CITY OF ALBUQUERQUE
MUNICIPAL DEVELOPMENT DEPARTMENT
ENGINEERING DIVISION

CONFERENCE RECAP

REF: DRAINAGE PLAN FOR BLAKE'S LOTABURGER AT MENAUL & CHELWOOD (H22-D31)

DRAINAGE STUDY
FOR
BLAKE'S LOTABURGER
MENAUL & CHELWOOD
ALBUQUERQUE, NEW MEXICO

SUBJECT Runoff Hydrograph
CLIENT Blatis Lotaberger JOB NO. _____
BY RHC. DATE 6-17-83 SHEET NO. 1 OF 2

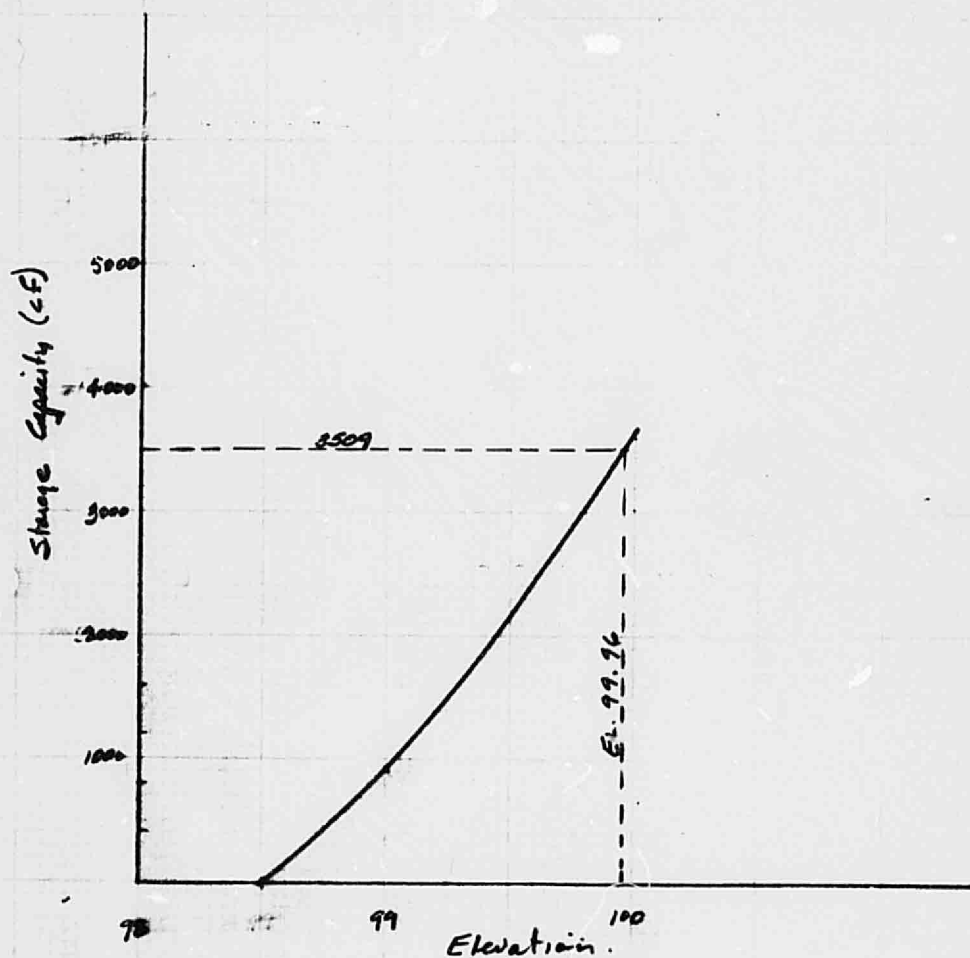
- (C.) I am enclosing the Runoff Hydrograph for the retention pond and the revised calculations. You will note we are using a small part of the parking area for storm water storage during the 100 year storm.

$$Q_p \text{ (Ponding)} = \frac{40.34 \times 2.9 \times 60}{2}$$

$Q_p = \underline{3509 \text{ cf}}$
